AGENDA
FARRAGUT MUNICIPAL PLANNING COMMISSION

January 19, 2017
7:00 p.m. Farragut Town Hall

Preliminary Subdivision Plat - Lot Layout
Easton Park
11739 Turkey Creek Road
Farragut, Tennessee
HFTC Partnership, GP

Preliminary Plat - Site Grading and Drainage Plan
N. Peterson Road Extension
Town of Farragut
N. Peterson Road
Farragut, Tennessee
JAN 10 2017

C1.0

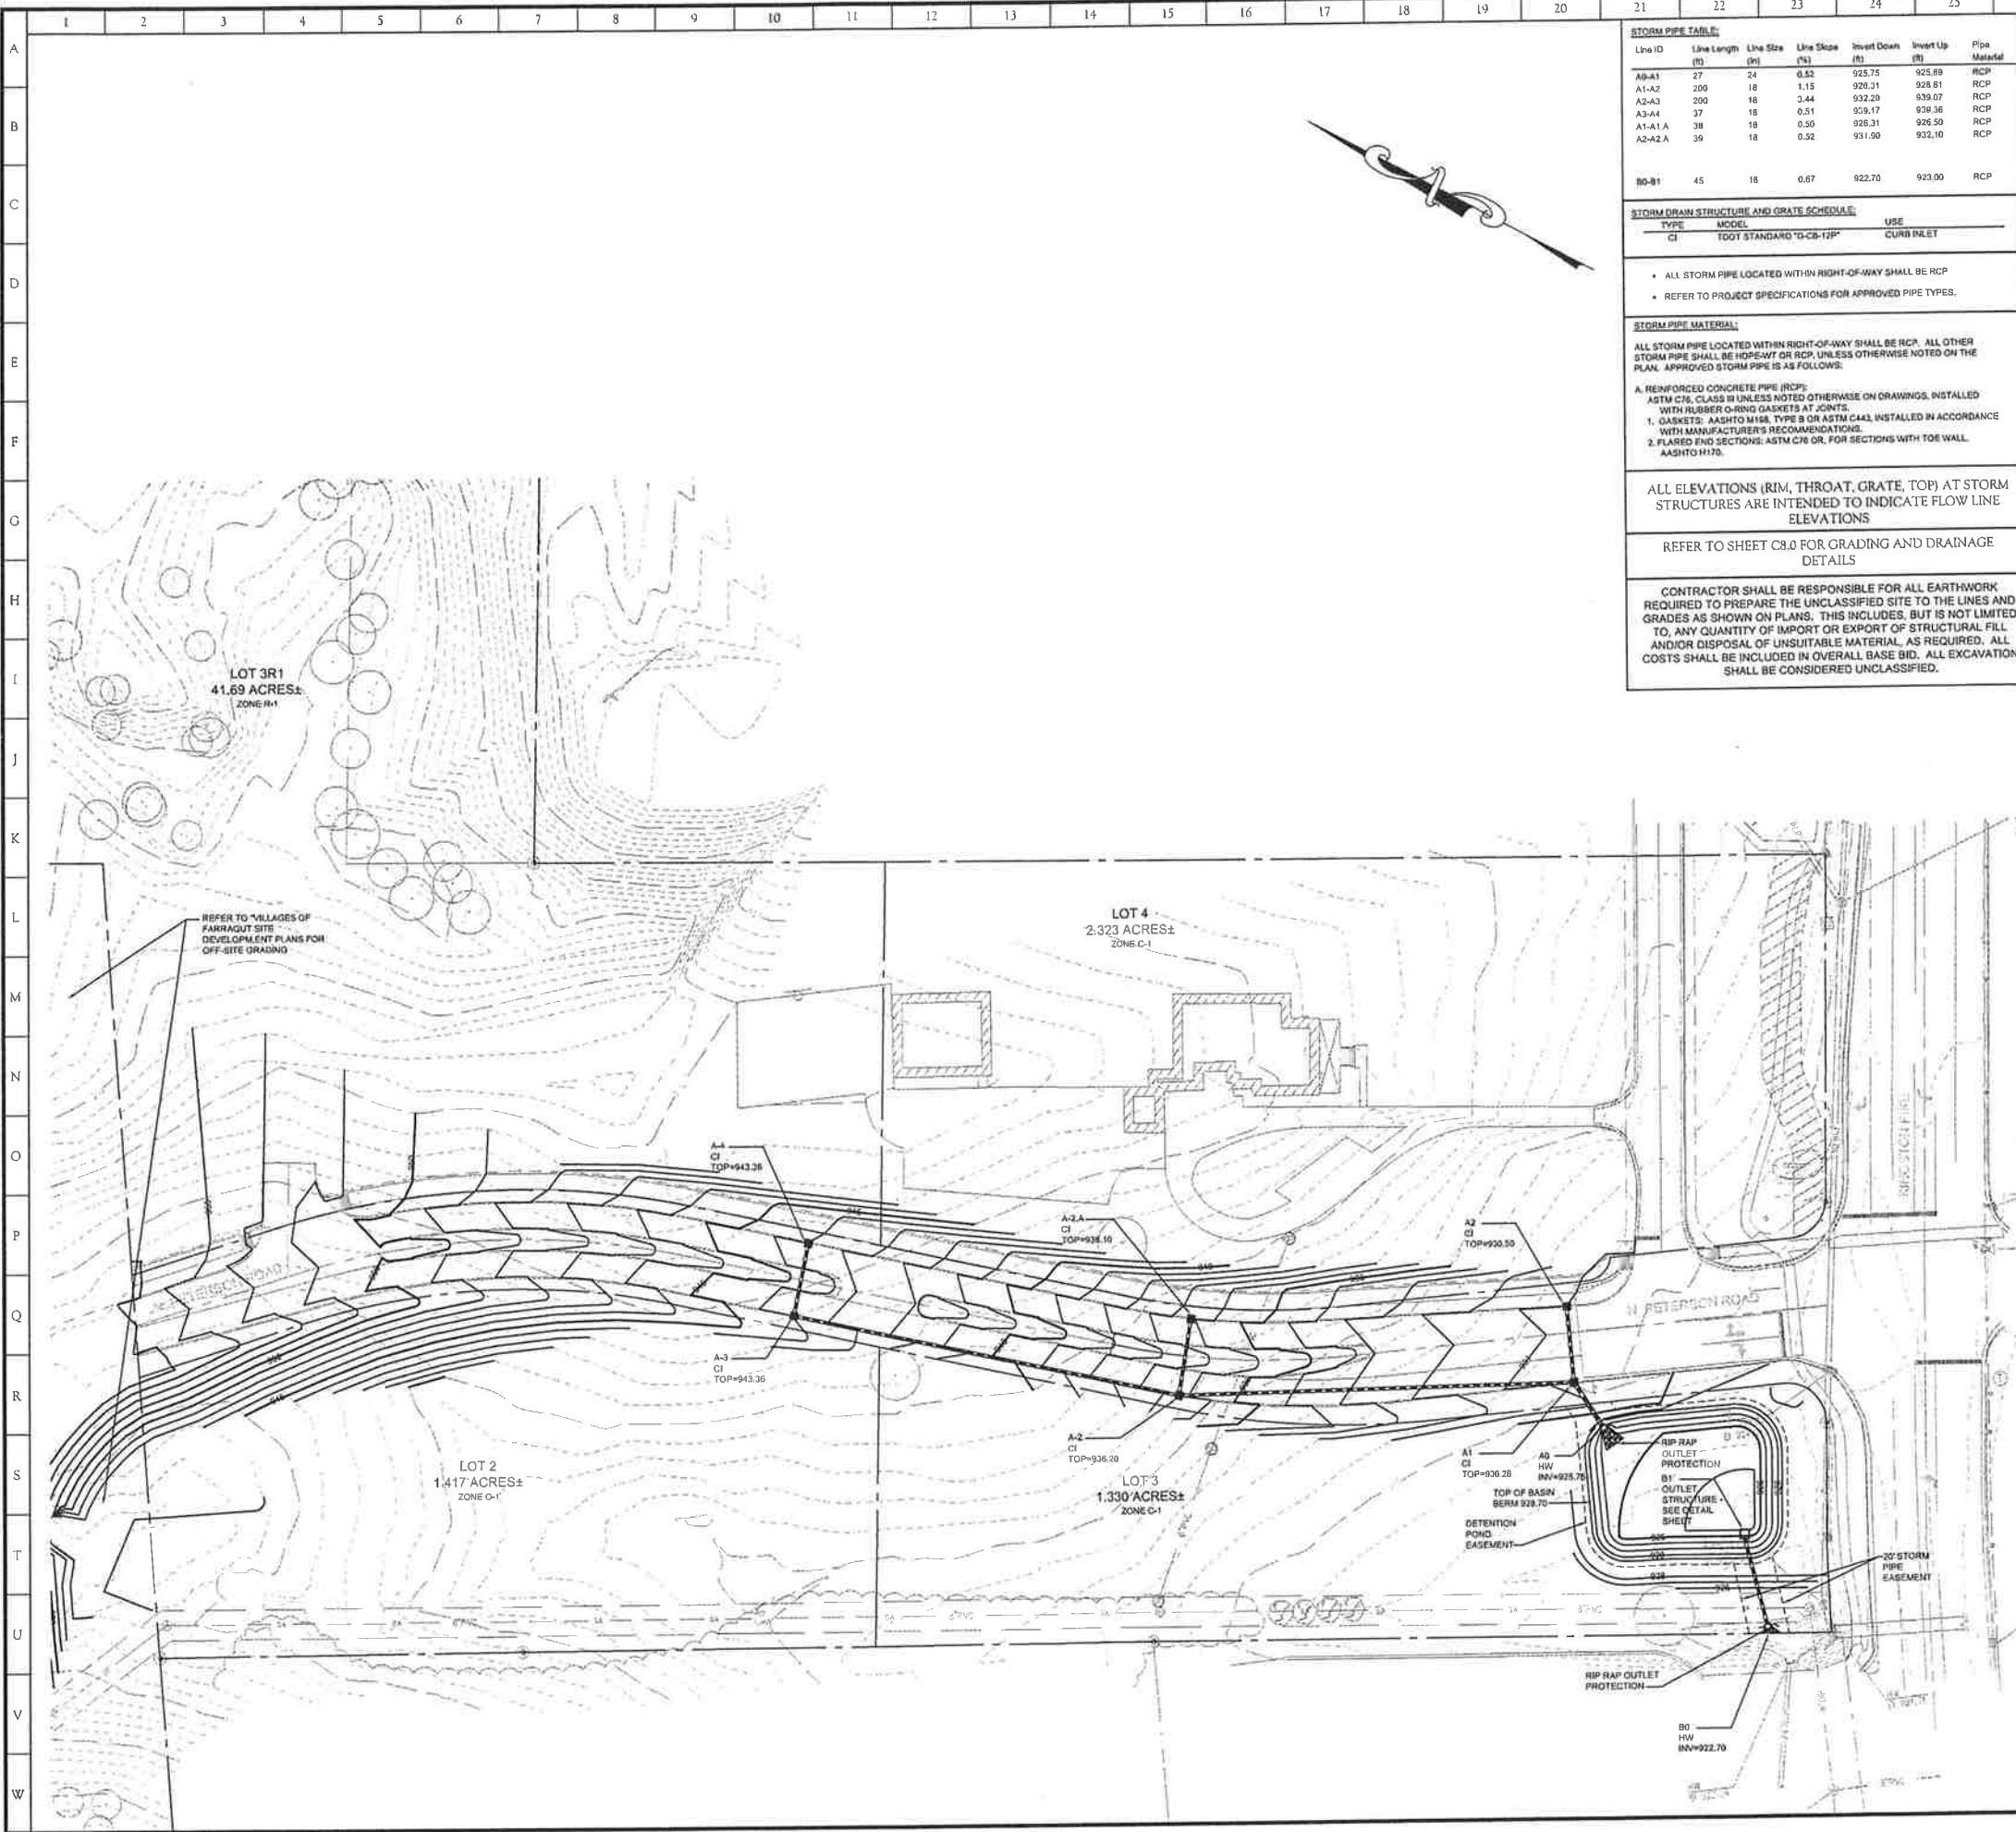
- 6) A general note has been added to the preliminary plat related to the property not being located in a special flood hazard area “per current FIRM map.” Please reference to the FIRM panel and effective date within the note that was utilized to make this assessment;
FIRM panel and date have been added the note. See sheet C1.0.

- 11) Please provide the correct tax map and parcel information for all affected tracts, this includes the future Villages of Farragut property;
Tax map and parcel information can be found on sheet C1.0.

- 12) The lots should be numbered in numerical order, please renumber and remove the “A” and “B” associated with several of the proposed lot numbers, as the new lots will be created as a result of the final plat that will be based on the lots shown on the preliminary plat;
Lots have been renumbered. See sheet C1.0.

C3.1
 SHEET 5 OF 10

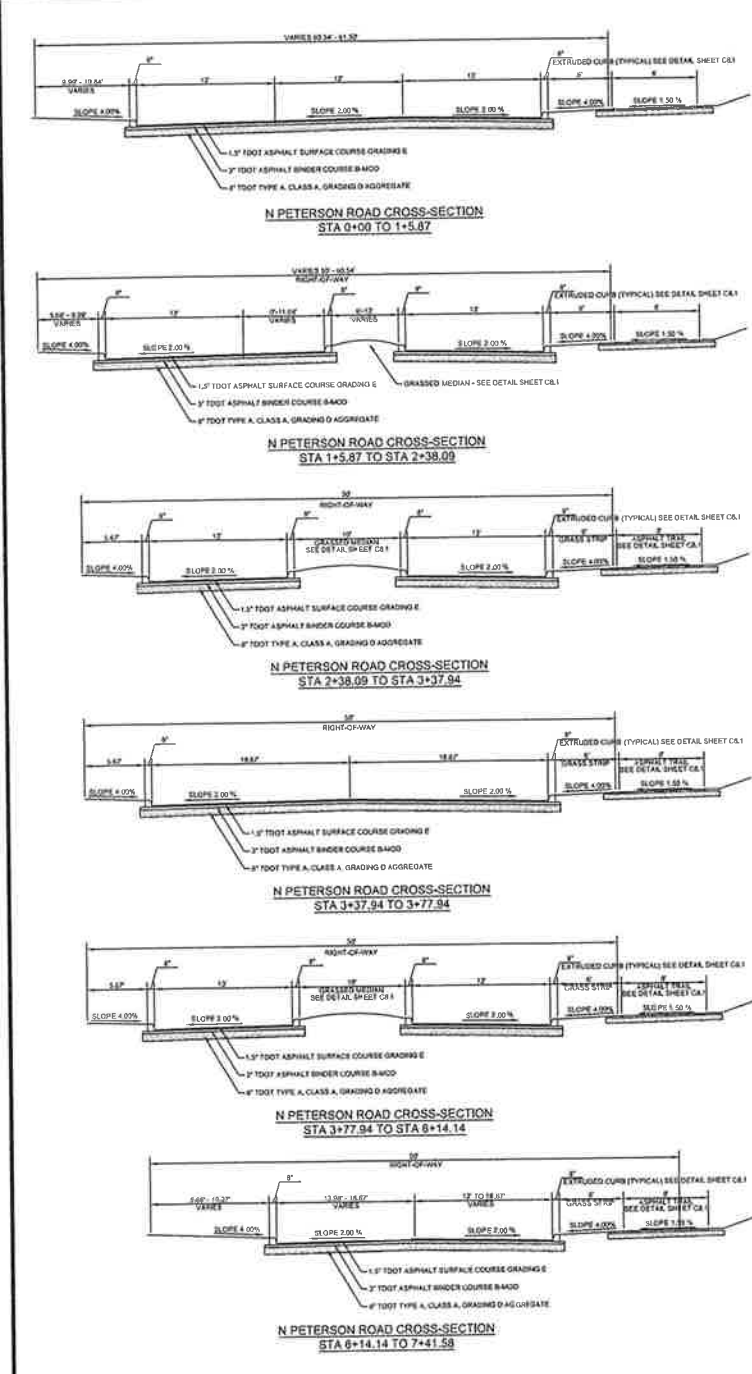
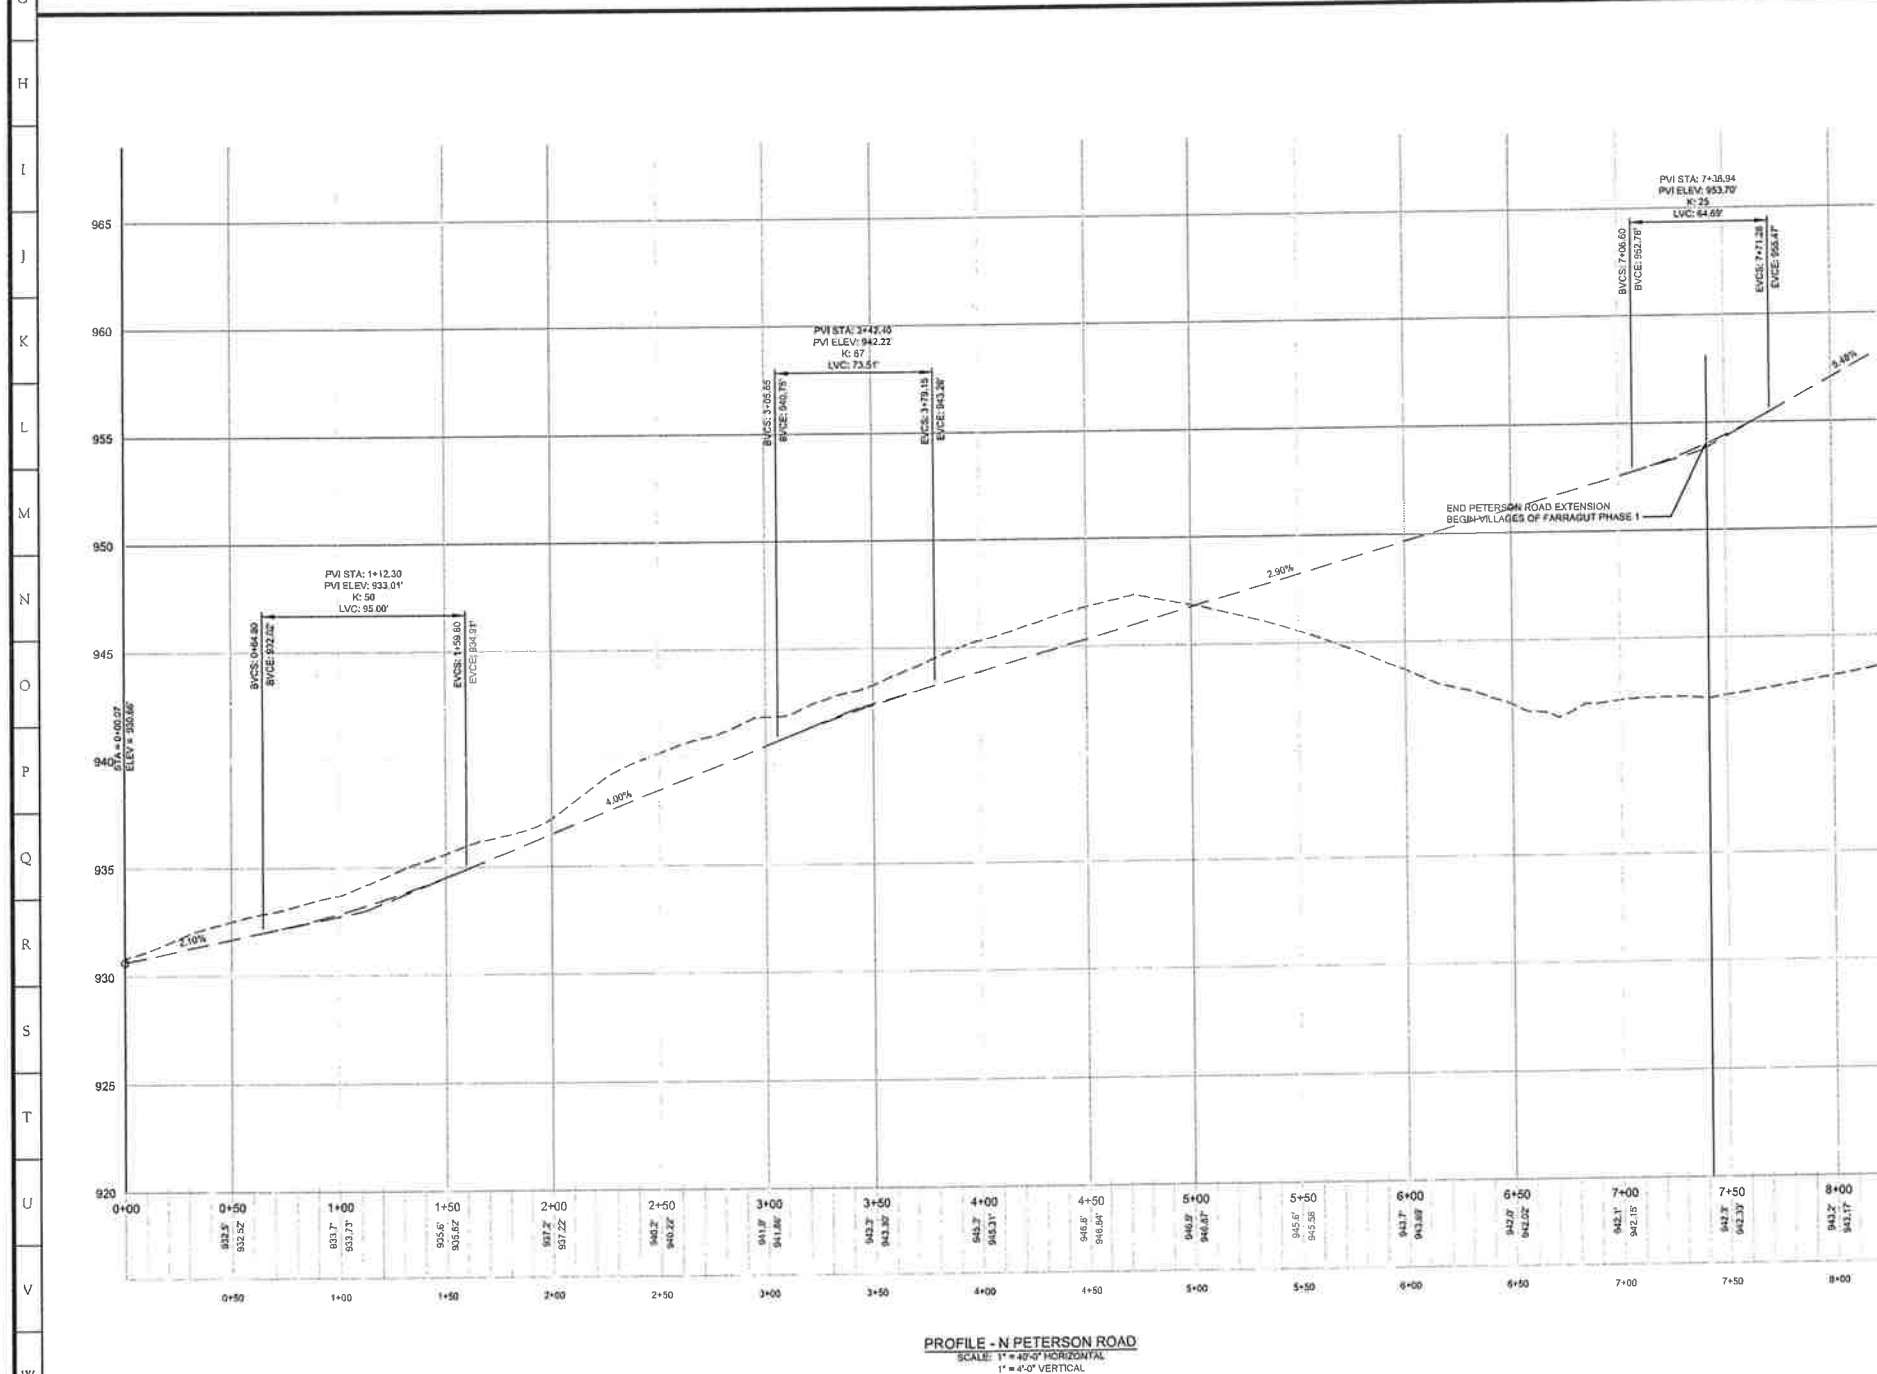
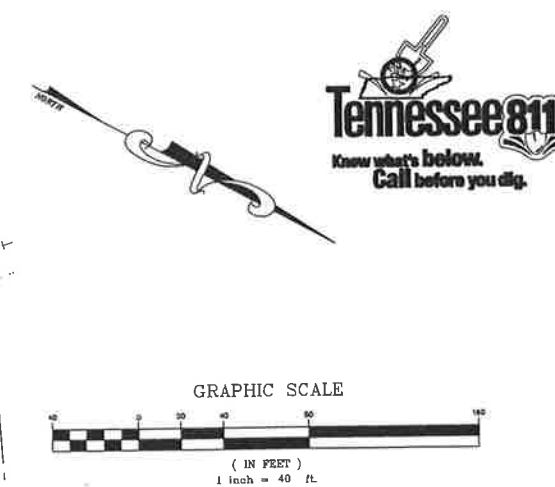
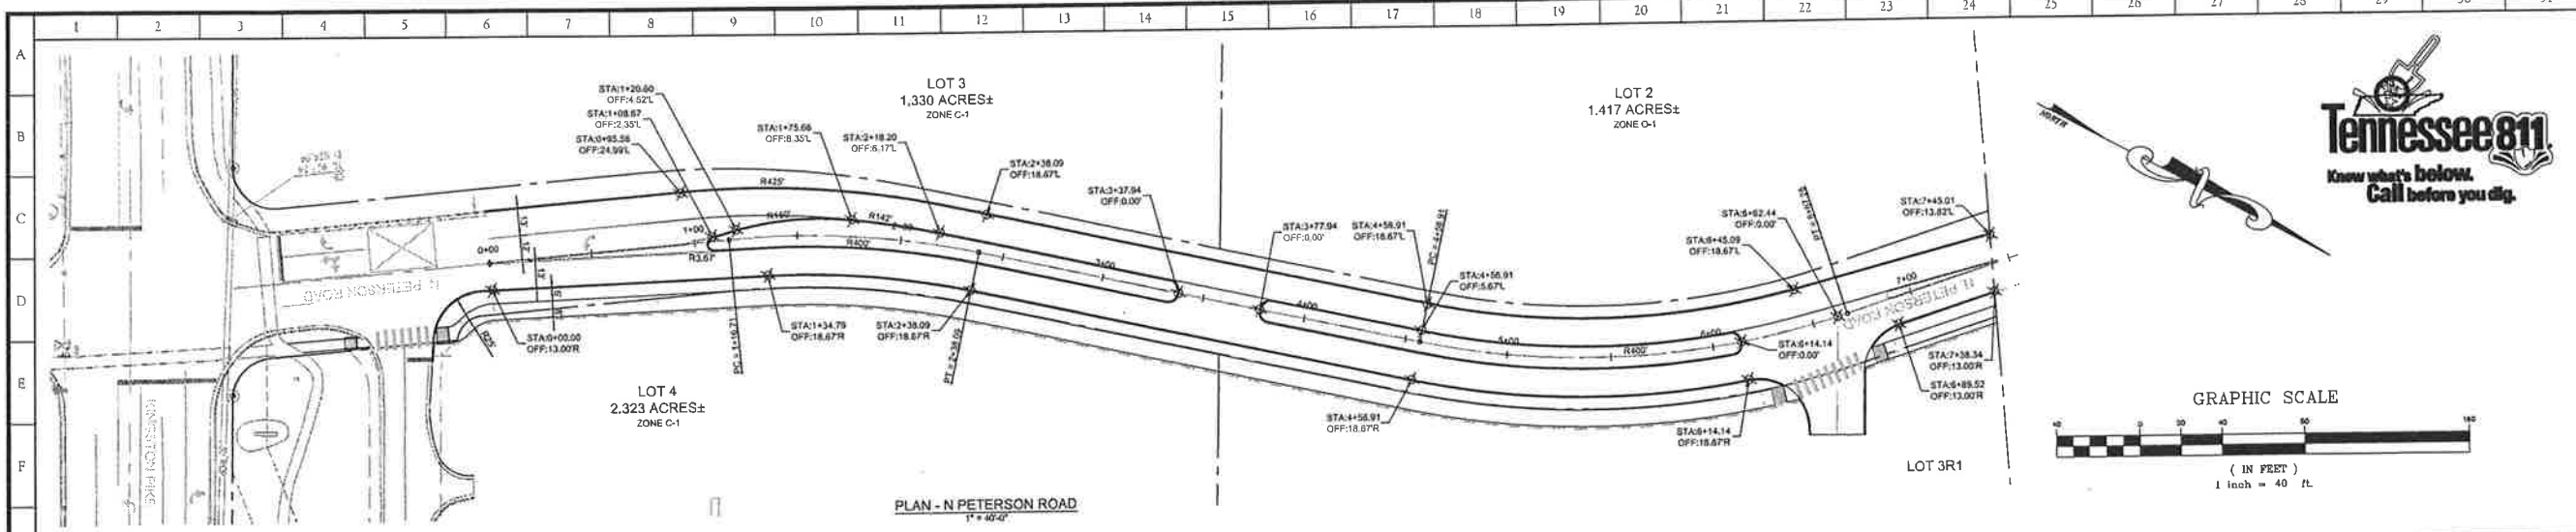
- 13) Please provide a tree protection plan for the trees to remain;
Tree Protection Plan has been provided. See Sheet C2.0.
- 14) Please revise the road cross-section to reflect the walking trail width;
Road cross sections have been revised to reflect the walking trail width. See sheet C3.1.

- 15) Please submit the erosion control plan (SWPPP);
Erosion control plans will be submitted with the Villages of Farragut Site Plan submittal since the erosion control for two projects must function together.
- 16) The Drainage calculations do not match detail of outfall structure. Please check the orifice and weir size/elevations;
The outfall structure detail has been revised to match the drainage calculations. See sheet C8.0.
- 17) Typical section should show median, along with details of curb. Will lane width be 13’ from curb to curb? With median, staff would prefer 6-30 curb & gutter on outside edges, in order to provide additional width. Will sidewalk be constructed on easements, or right of way? Typical should show sidewalk cross slope as “2% maximum” to avoid issues with ADA compliance. Suggest “1.5% (2% max.)”;

The cross sections have been revised to show the various conditions. We have indicated a cross slope of 1.50% in the typical cross sections. The property owner would prefer to construct the 8" extruded curb. See sheet C3.1.
